PROPOSED AMENDMENT TO

LAND DEVELOPMENT CODE SECTIONS 3.00.01, 4.03.07, 4.04.03 AND 7.01.08

Prepared for the July 13, 2006 meeting of the Local Planning Board

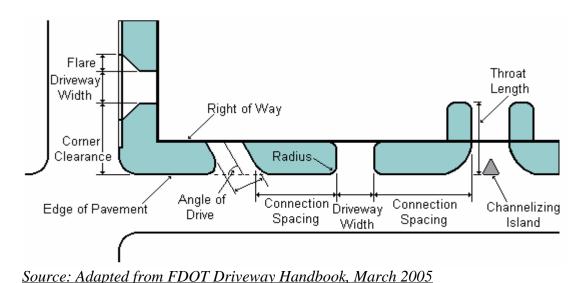
6. Driveway Standards: Driveway design features shall be considered as shown in the graphic below.

New graphic.
